From: Steve Willis
To: Wayne Miller
Date: April 10, 2019
Subject: Review of the U.S. Air Force's Evaluation Summary for Potential Additional Monitoring Wells, ST012, Former Williams Air Force Base, received April 8, 2019.

UXO Pro Review of the U.S. Air Force's Evaluation Summary for Potential Additional Monitoring Wells, Site ST012, Former Williams Air Force Base, Mesa, Arizona

Mesa, Arizona
 Site ST012 - Former Williams Air Force Base
 ST012-CZ Benzene Concentration,
 Well Locations, and Injection Areas

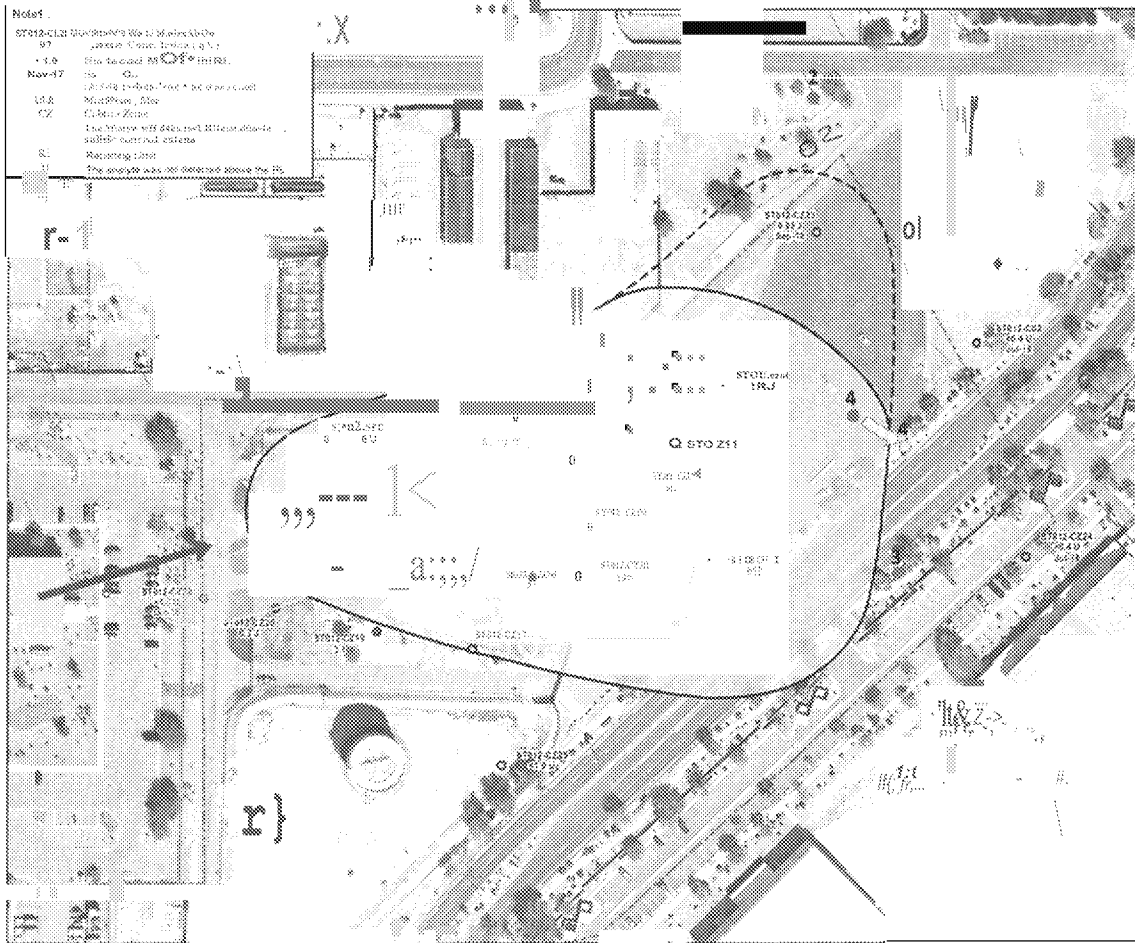
1. Cobble Zone Location 2. The Air Force (AF) recommends this location be medium priority only if concentrations increase again at well CZ23. Benzene was reported at 97 ug/L in April 2018 prior to the start of groundwater extraction at upgradient well CZ07. Hence, it's likely that high benzene concentrations extended significantly beyond well CZ23 at that time. AF's contractor has not provided a capture zone analysis for the CZ07 pumping, so we don't know if the capture zone extends beyond CZ23. ADEQ should continue to push for a capture zone analysis, or AF should provide the regulatory agencies with the required information to complete the analysis.

2. UWBZ Locations 1 and 2. AF recommends combining locations 1 and 2 and installing a single well between the two locations. Since the wells are relatively close together combining the wells is a reasonable option, and ADEQ should concur. However, additional wells further downgradient (N-NE of Location 1) should be considered for a follow-on phase.

Commented [DE1]: Recall that during the March 21, 2019 conference call the AF reported that the march 1, 2019 sample from this well contained 24ug/L benzene, and a subsequent sample had a concentration of 47 ug/L. that should change the priority of this well to High.

Commented [DE2]: Combining these 2 wells into one as shown on the AF figure leaves considerable northern boundary extent in the UWBZ that is not defined (see dashed line to the north in the figure). This would not fulfill ADEQ objective of defining the plume.
